**NSLPP MEETING HELD ON 06/07/2022****Attachments:**

ADDRESS/WARD: 18 Tobruk Avenue, Cremorne (S)**APPLICATION No:** DA 56/22**PROPOSAL:** Demolition of existing structures, retain and extend existing garage, construction of a dual occupancy (attached) and associated works.**PLANS REF:**

OWNER: Gumtree Lane Australia Pty Ltd**APPLICANT:** Platino Properties**AUTHOR:** Andrew Beveridge, Assessment Officer**DATE OF REPORT:** 6 July 2022**DATE LODGED:** 21 February 2022**RECOMMENDATION:** Approval

Figure 11. The building height blanket diagram.

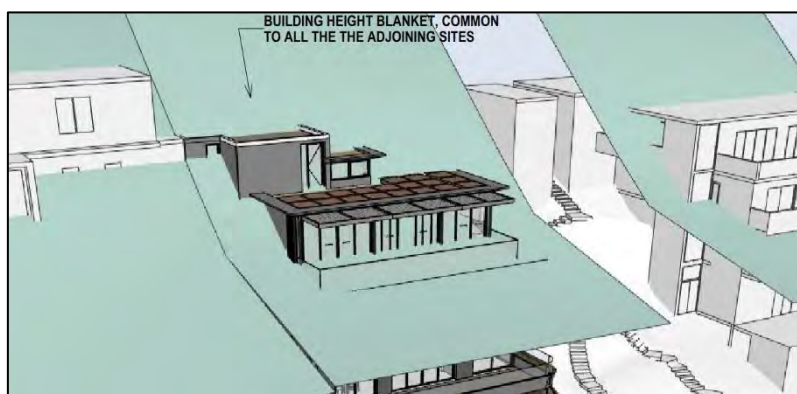
Due to the steep natural fall of the site, a part of the western end of the garage at Street Level (FFL 44.81) and the majority of Level 4 below (FFL 41.80) are above the 8.5m high limit at 13.5m (Eastern end of garage, lift section at Street level – 5m or 58.8%) and 11.7m (Level 4 – 3.2m or 37.6%). Consequently, this requires a variation of the Development Standard in clause 4.3 in NSLEP 2013 (see discussion below).

DA.13

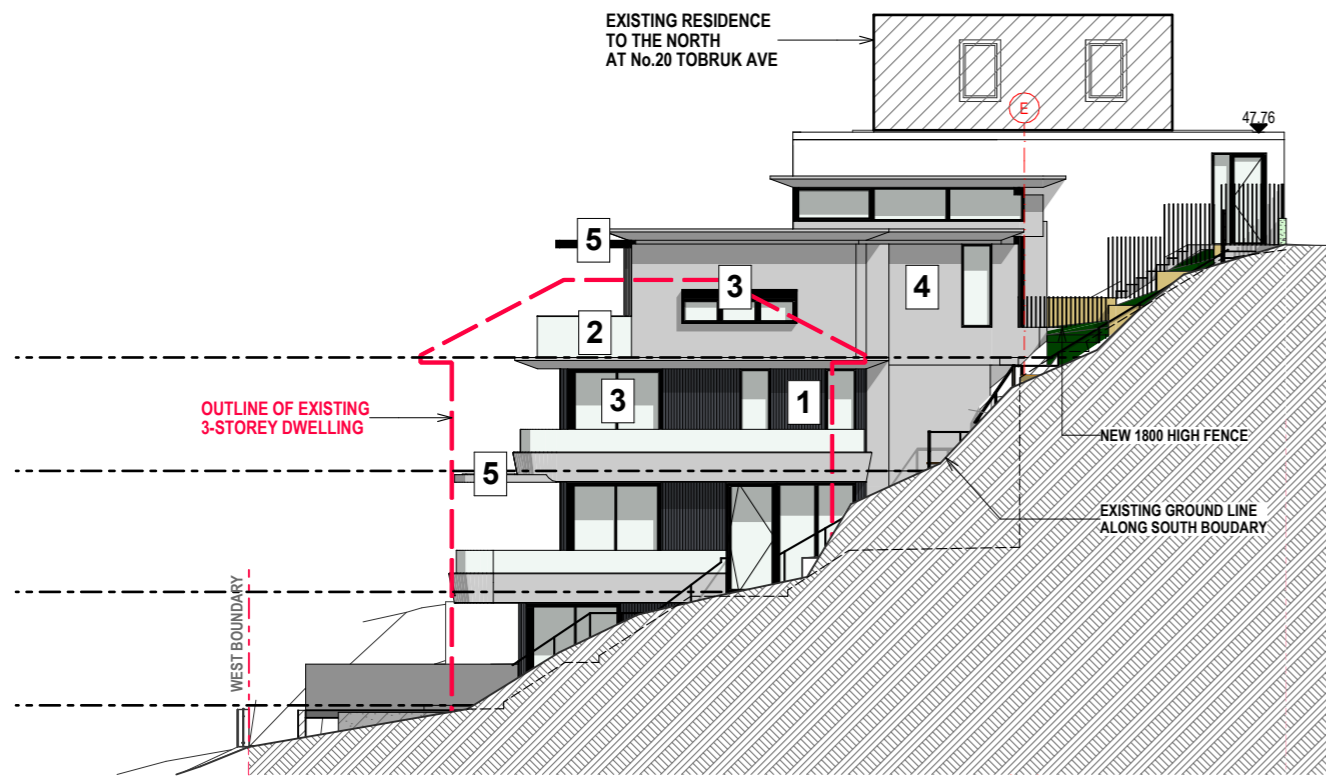
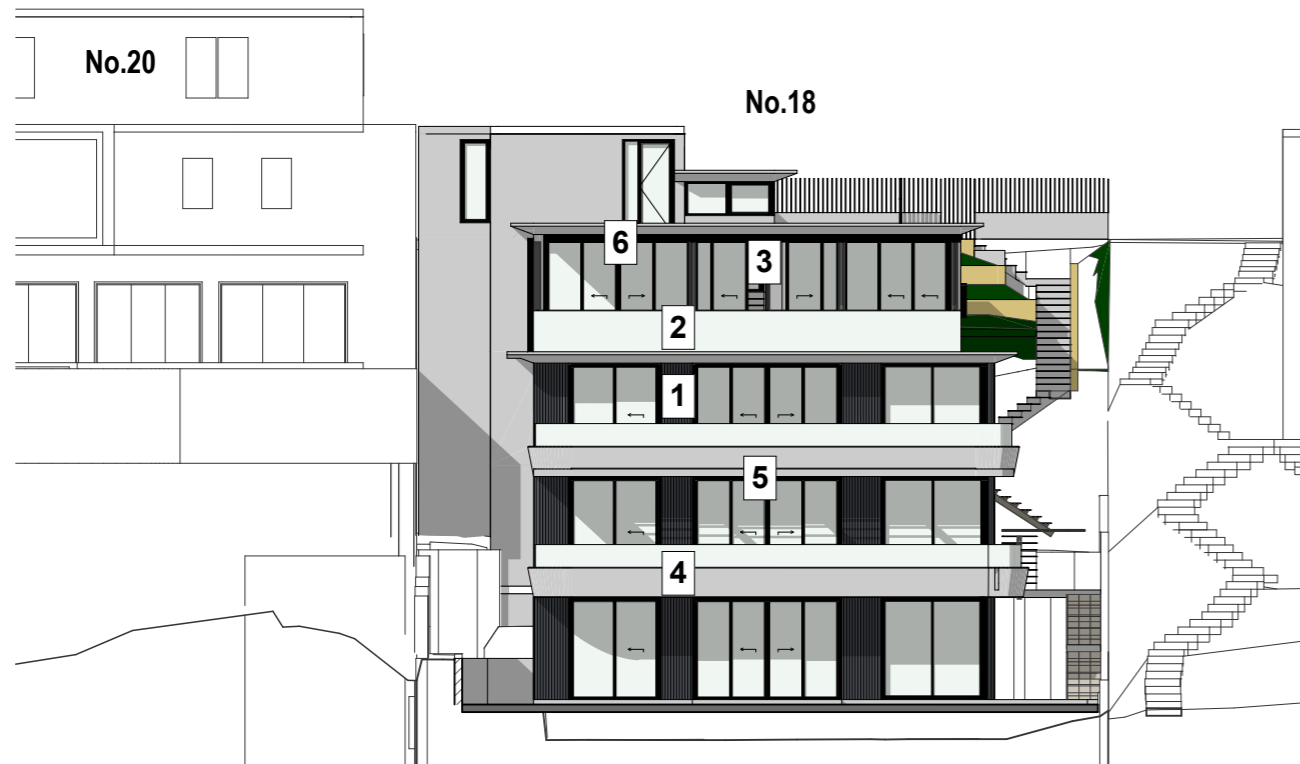
Colours and materials	Yes	The majority of proposed colours and materials are acceptable. However, it is recommended that the proposed 'Dulux Monument' colour for external walls is replaced by a more muted tone that is sympathetic to the neighbourhood and nearby bushland (see Condition A4). The used of masonry and metal in the design assists in breaking up the exterior of the development and ensures that glazing does not dominate the facades, particularly at the rear. The use of masonry to the lower section of the lower two balconies combined with planter boxes on the sides also reduces the amount of visible glazing.
Front fences	Yes	The proposed front fence will be a metal palisade structure up to 1.5m in height, with a solid masonry base. The partially open design will allow for filtered views from the street to the front garden and the building beyond.

- A4. External finishes and materials must be in accordance with the submitted schedule numbered DA.13, dated 4 February 2022, prepared by PA Studio, and received by Council on 21 February 2022, unless otherwise modified by Council in writing. The proposed colour 'Dulux Monument' identified for external walls, is to be deleted from the plans and replaced with a more recessive, muted colour that is more in keeping with the surrounding neighbourhood and nearby bushland.

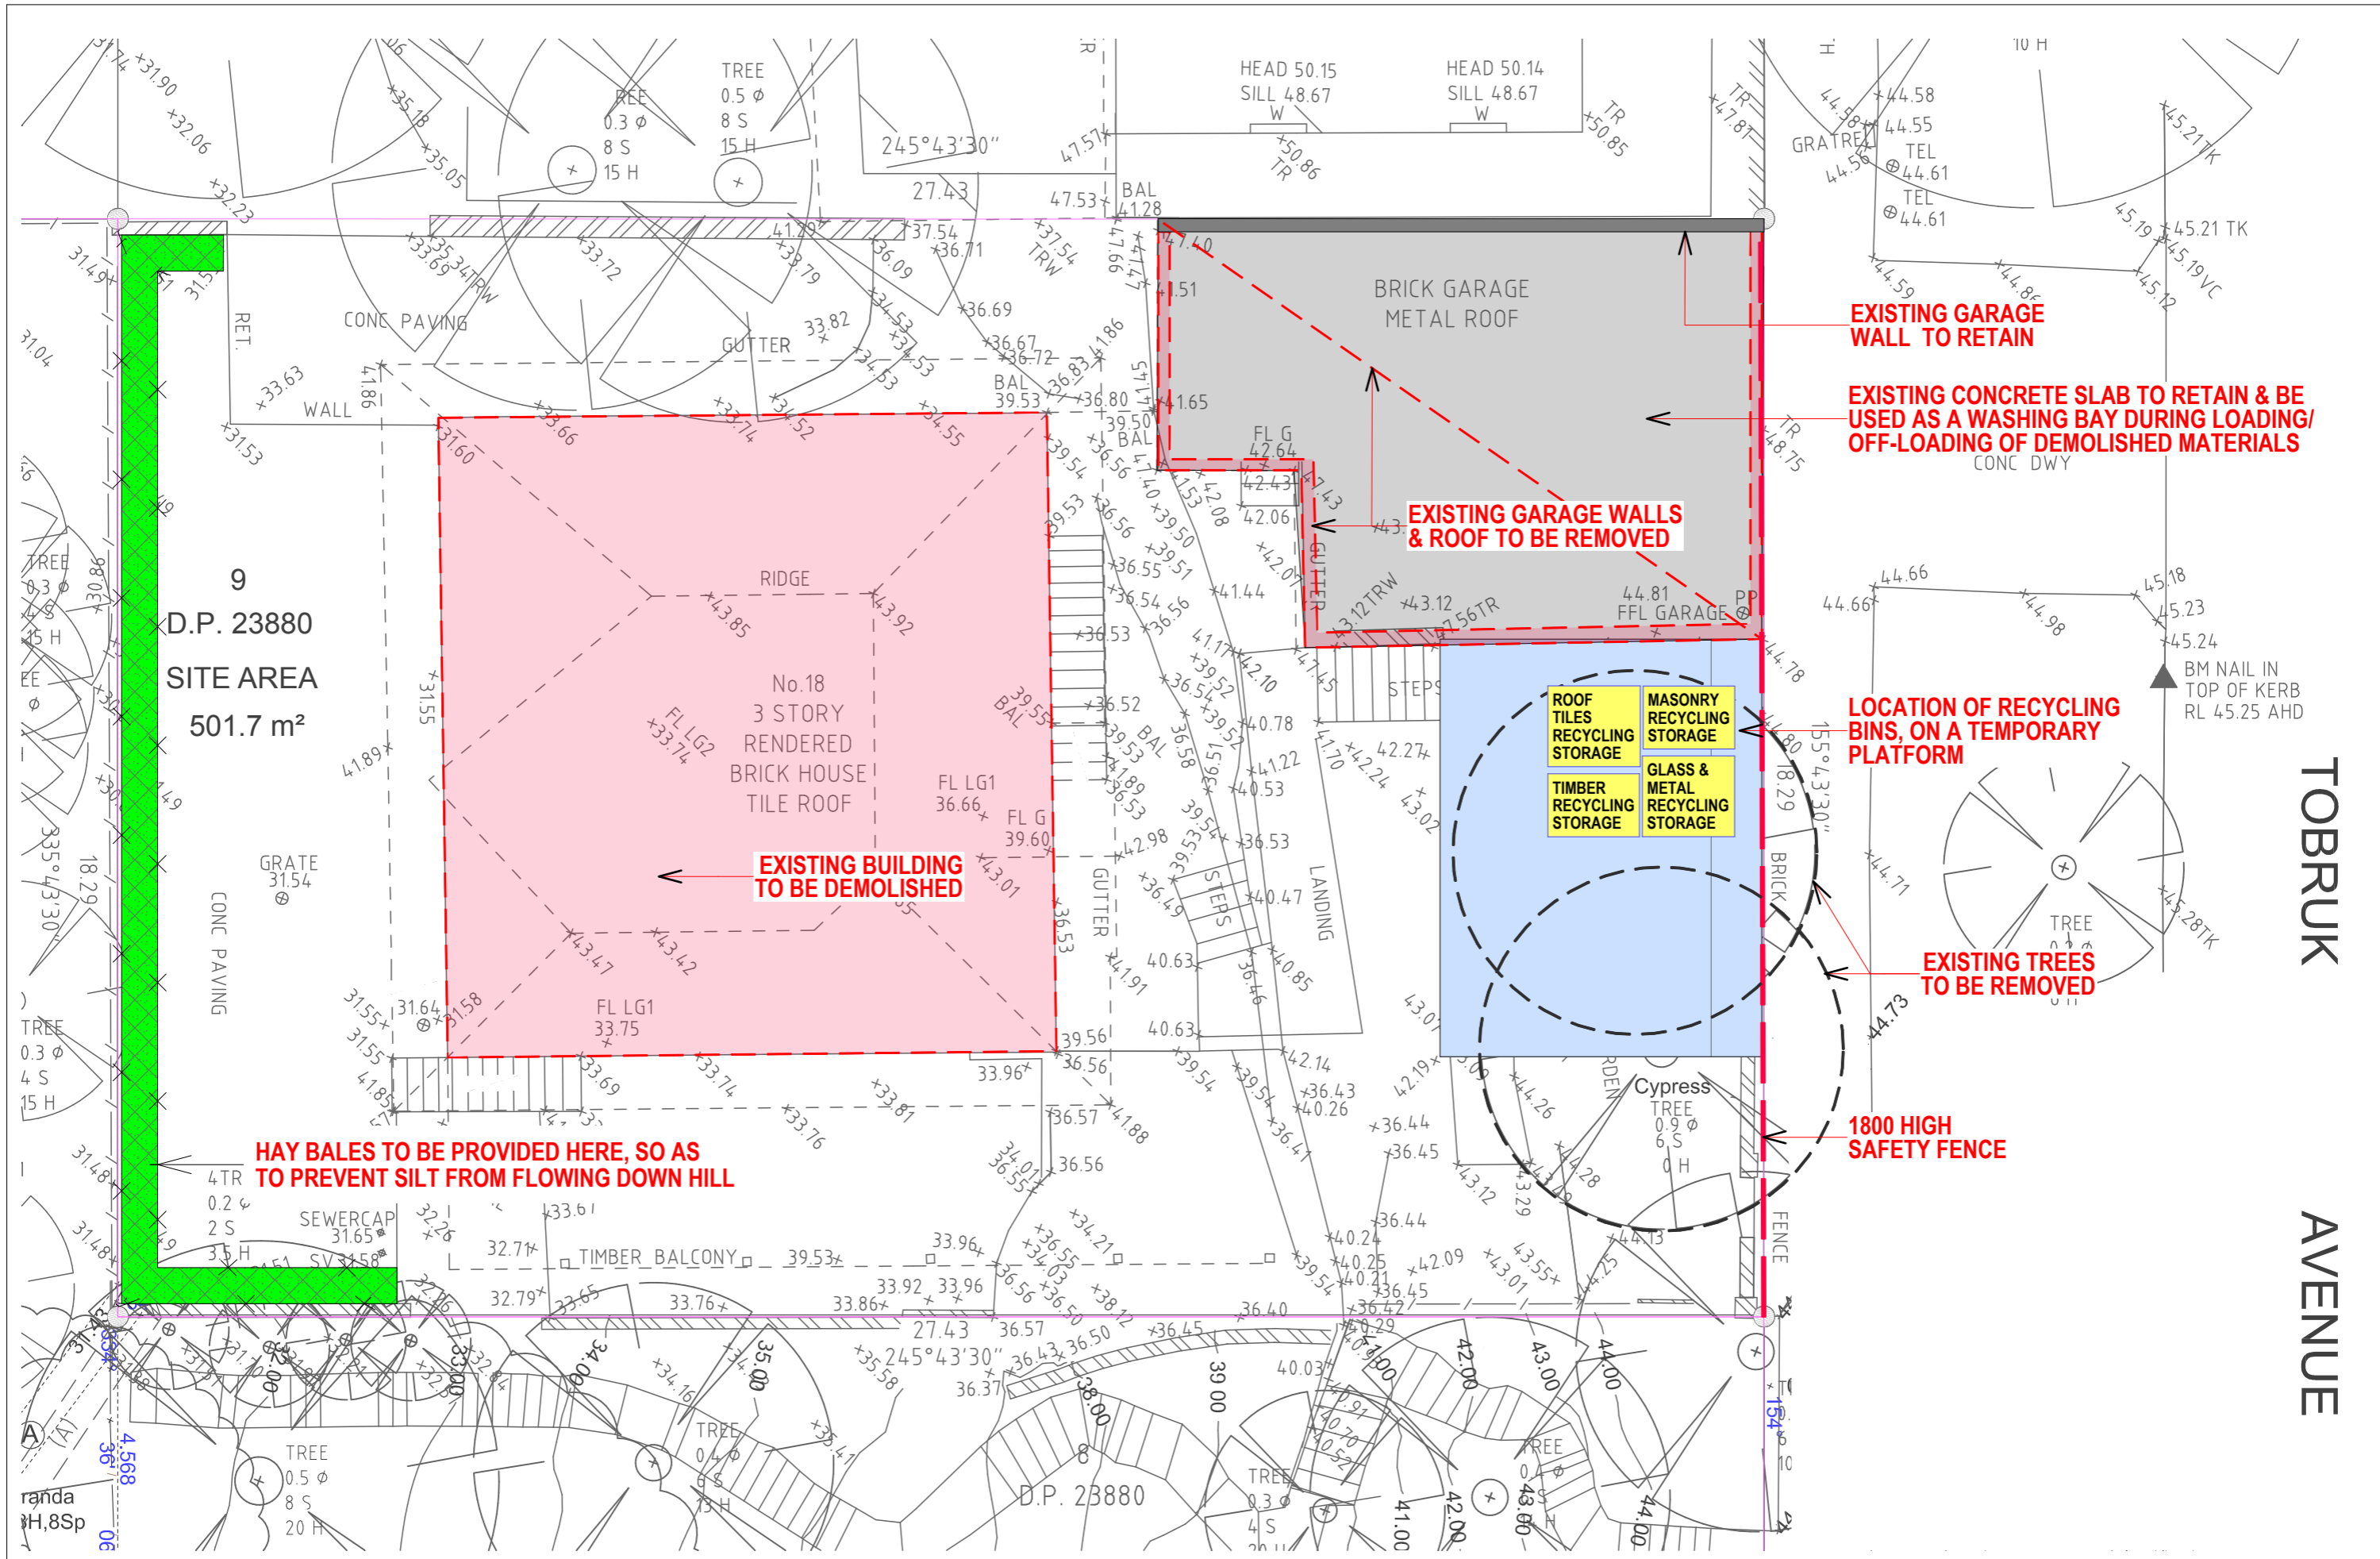
- *No stormwater shall be routed through the TPZ of any protected tree.*
- *The landscape plan prepared by Space LS Design dated 11/2/22 shall be amended as follows:*

- o *The 2 x *Elaeocarpus reticulatus* shall be 75-litre, not 45l as shown.*
 - o *The *Cyathea australis* shall be planted with trunk height of 800mm minimum (not the 200mm pot size shown)*

- 1) 1 x additional *Tristanopsis laurina* (100-litre pot size) shall be planted in the Council verge in front of 18 Tobruk Avenue, to the south of T3 *Tristanopsis laurina*.
- 2) T1 and T2 (*Chamaecyparis sp.*) within the front setback are to be replaced with the additional planting of 2 x *Ceratopetalum apetalum* (100-litre pot size) along the southern boundary, 1 x *Buckinghamia celissima* (100-litre pot size) and 2 x *Tristanopsis laurina* (100-litre pot size) within the rear setback.
- 3) The 2 x *Elaeocarpus reticulatus* shall be 75 litres in pot size (not 45-litre as shown).
- 4) The *Cyathea australis* shall be planted with a trunk height of 800mm minimum (not the 200mm pot size shown).
